EDGE-ON-HUDSON

APPLICATION FOR SITE PLAN & SUBDIVISION APPROVAL

PHASE ONE SUPPLEMENTAL SUBMISSION

Re: Phase 1 Site Plan and Subdivision Application
Edge-On-Hudson Riverfront Development
199 Beekman Avenue, Sleepy Hollow

DRAWN BY: BZ/JEB	CHECKED BY: AVT/MSG
	PROJECT NO: 780	DATE: 07/15/15
DRAWING NO.: 		SP-0.2

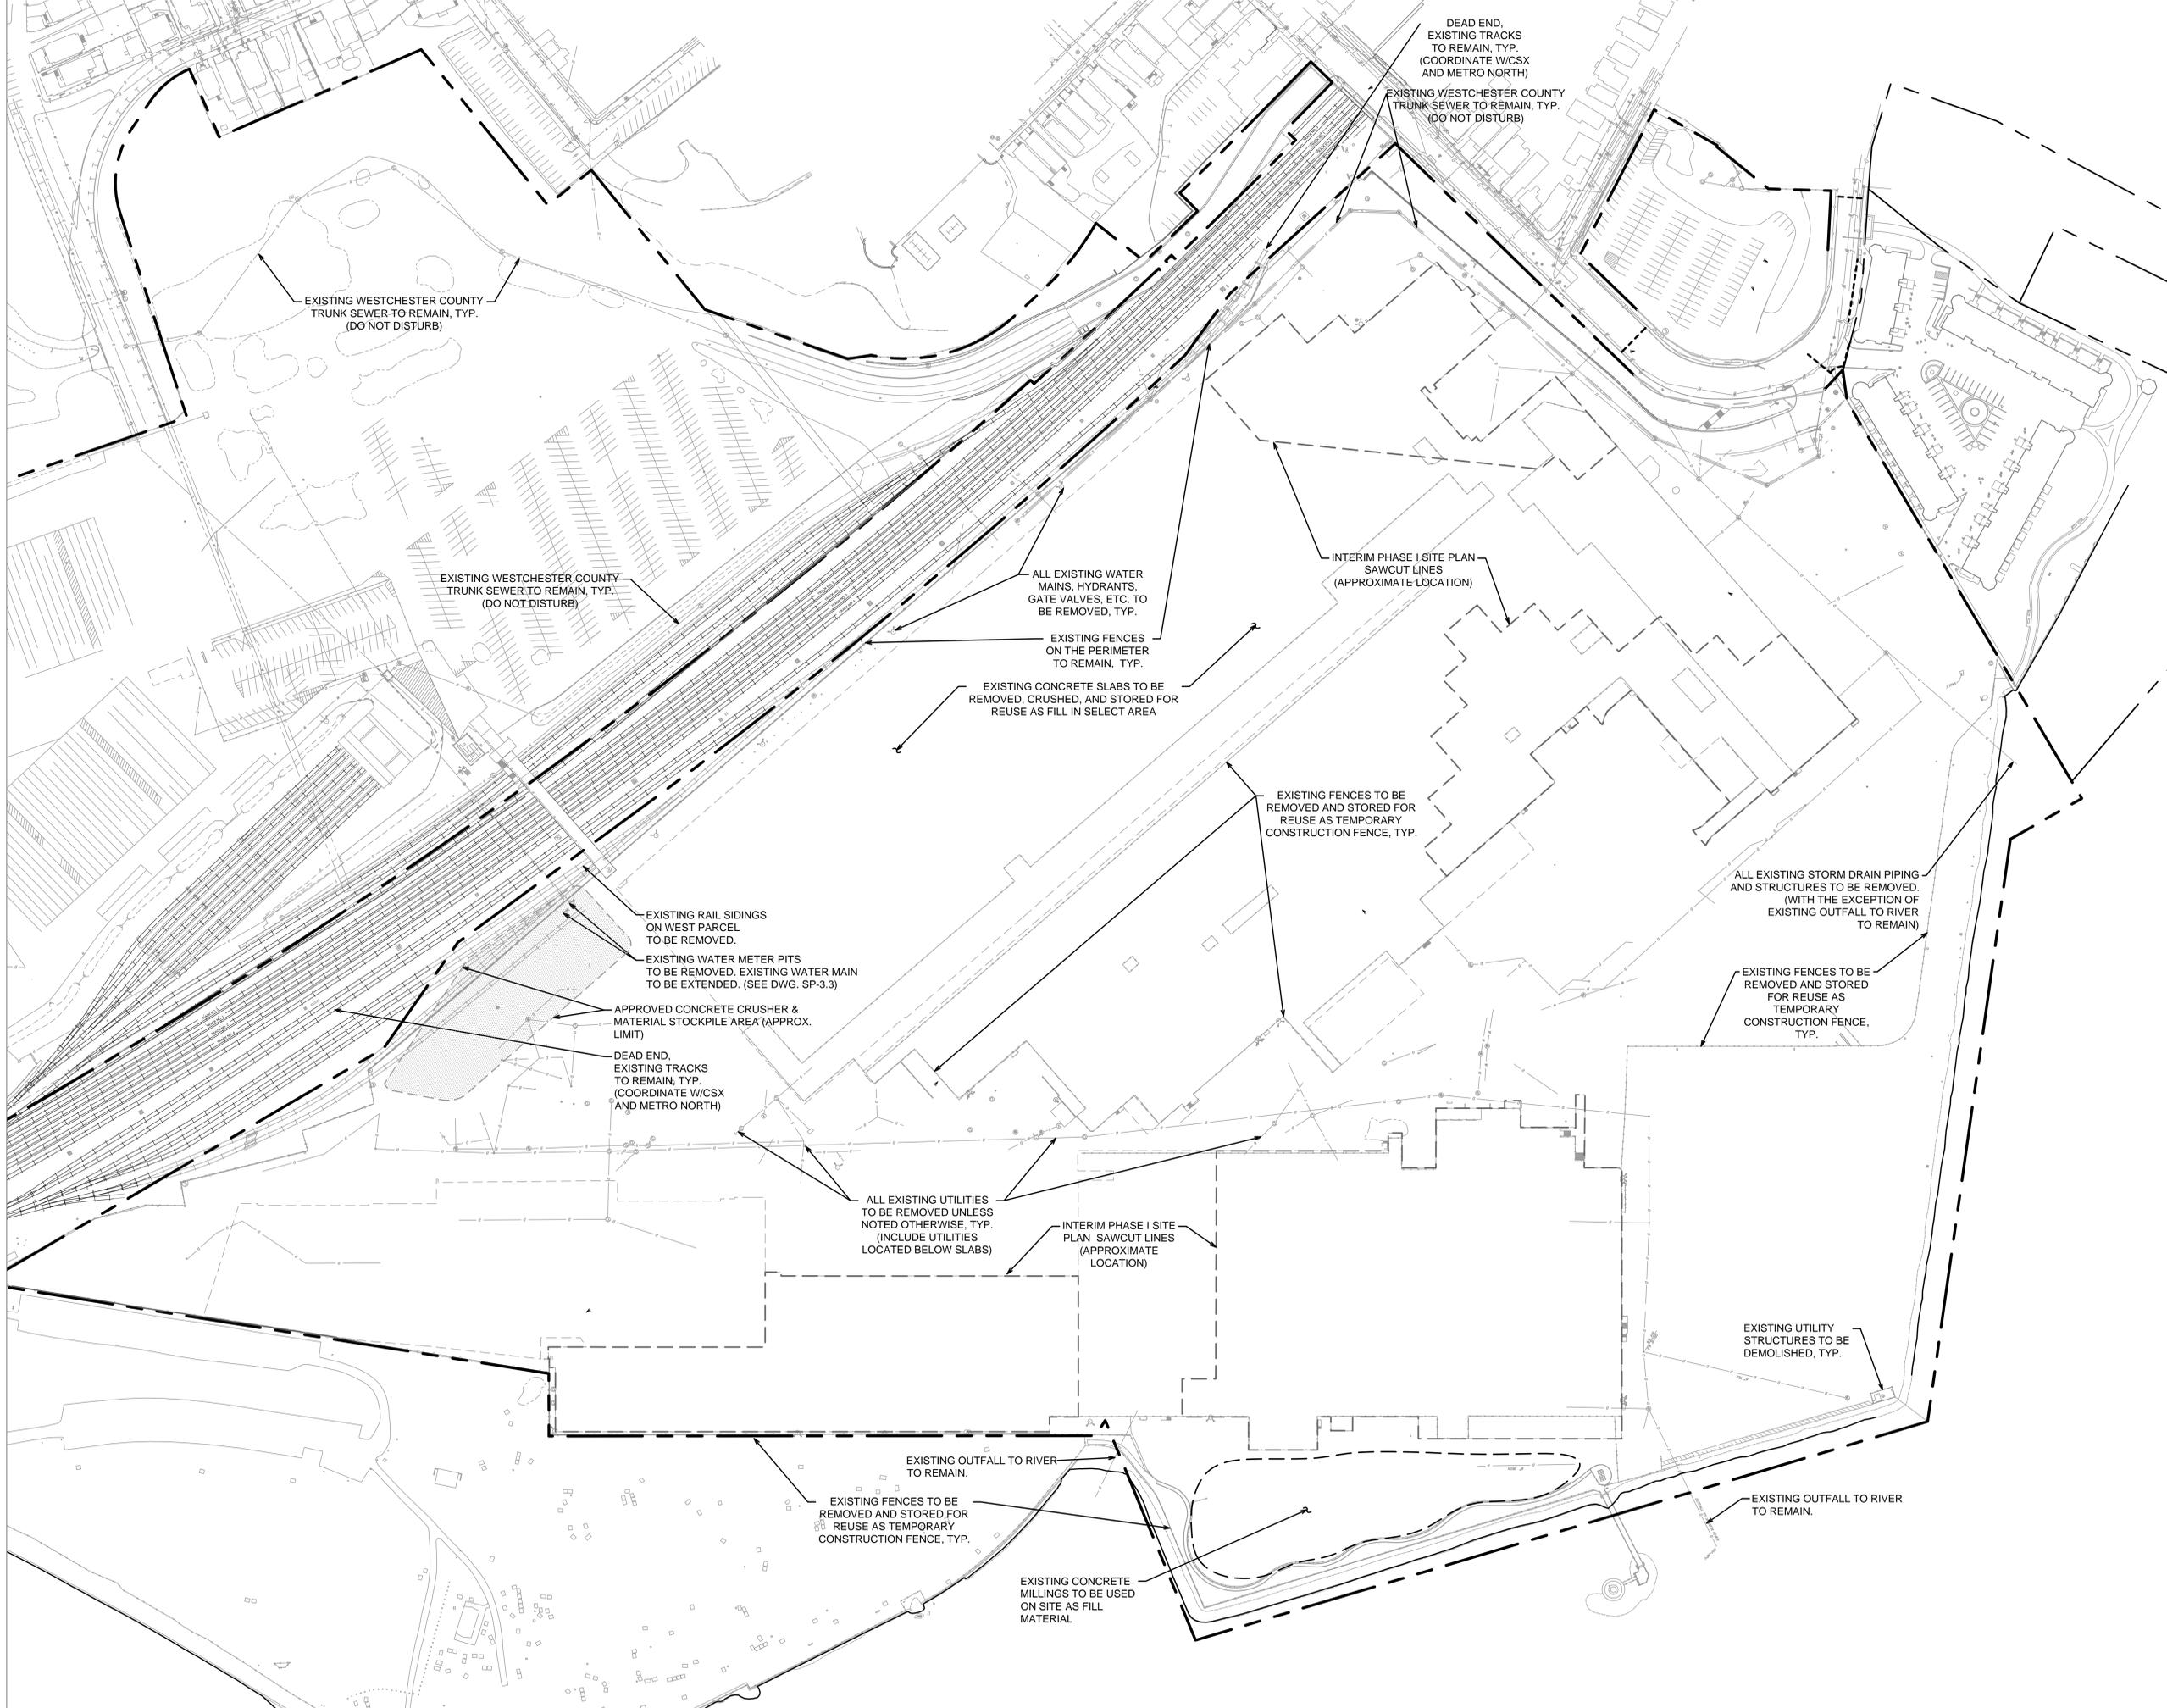
G4. **Comment:** *The Stormwater Pollution Prevention Plan mentions that existing site utility infrastructure will be demolished. A demolition plan must be included in the full set of plans.*

Response: A Demolition Plan, Sheet SP-0.2, is included in this revised plan set.

SP-1.1

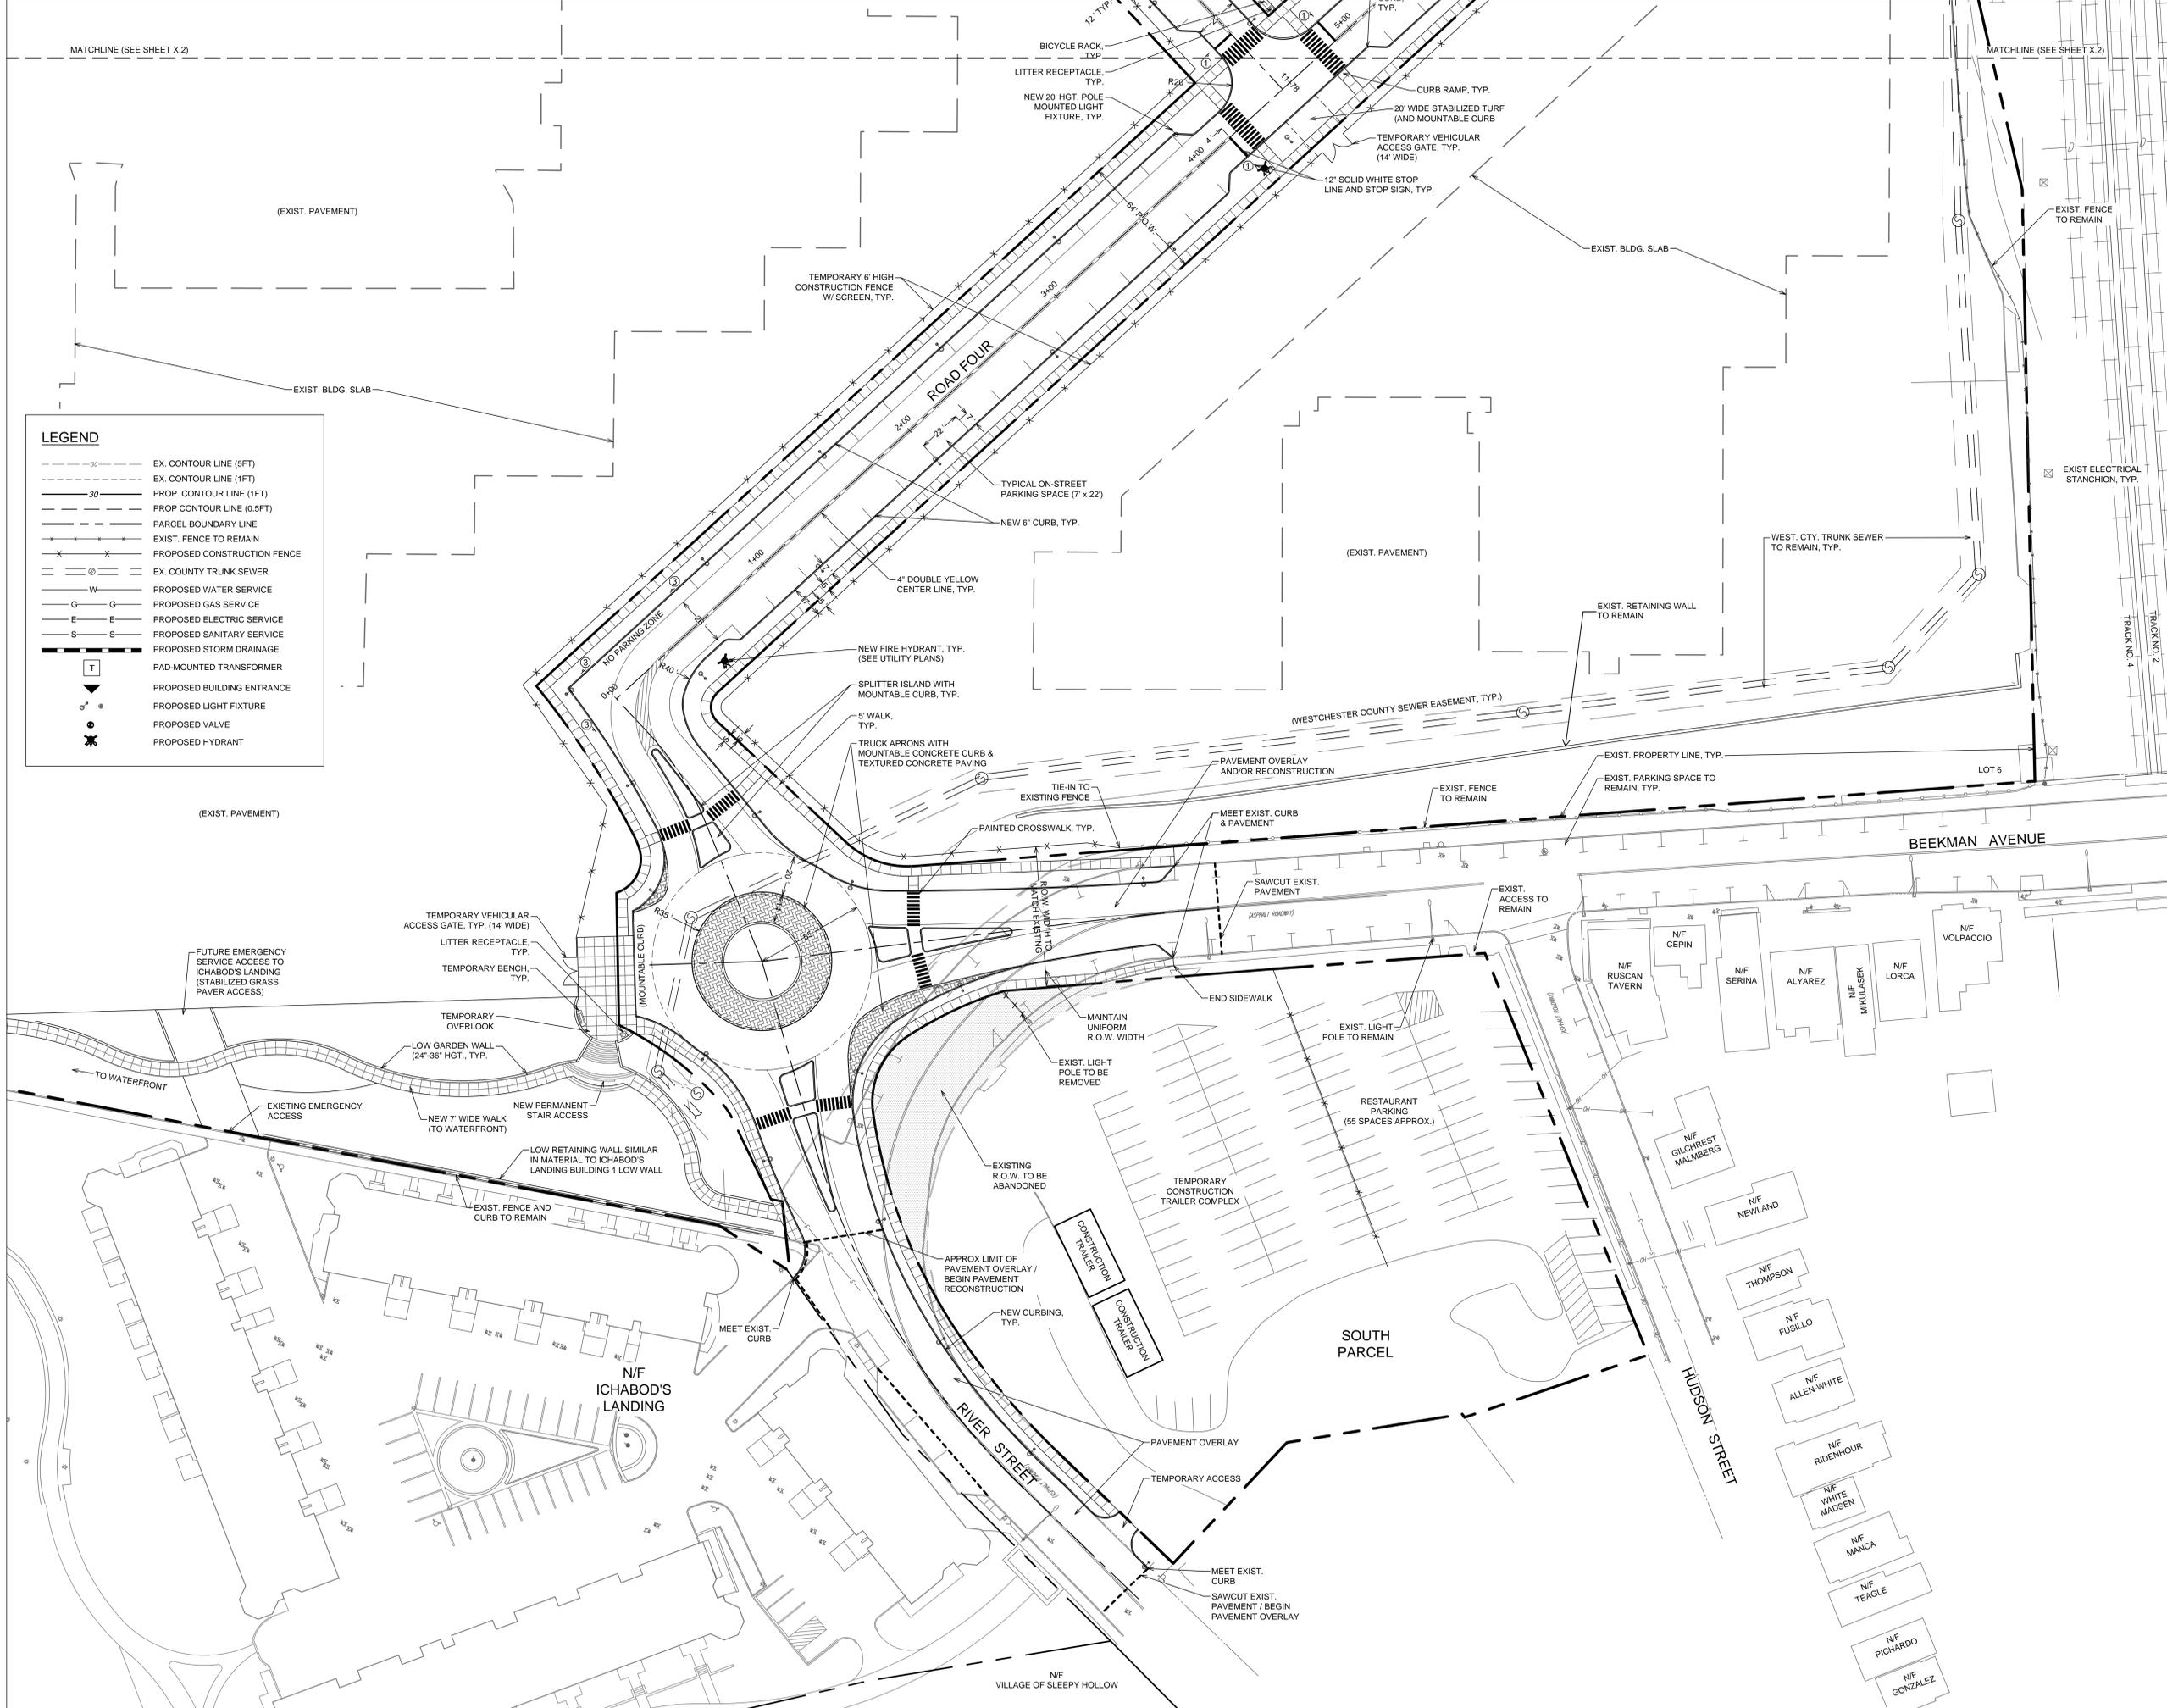
G5. **Comment** *The limit of concrete slab saw cutting for Phase I must be indicated on the plan.*

G7. **Comment** *A detail for granite curbs has been provided. Plans indicate concrete curb in some locations and the curb material is not specified in others. Where are these proposed?*

Response The Applicant intends to demolish all concrete building slabs within the site during the first phase of construction. The approximate location of interim saw cut lines for the required Phase I Site Plan slab demolition area are shown on Sheets SP-1.1 through SP-1.3.

Response Granite curbing is proposed to be used within all public right-of-way areas and the Block E center court area. All other curbing will be concrete. Refer to Sheets SP-1.1 through SP-1.3 for the updated Site Layout Plans.
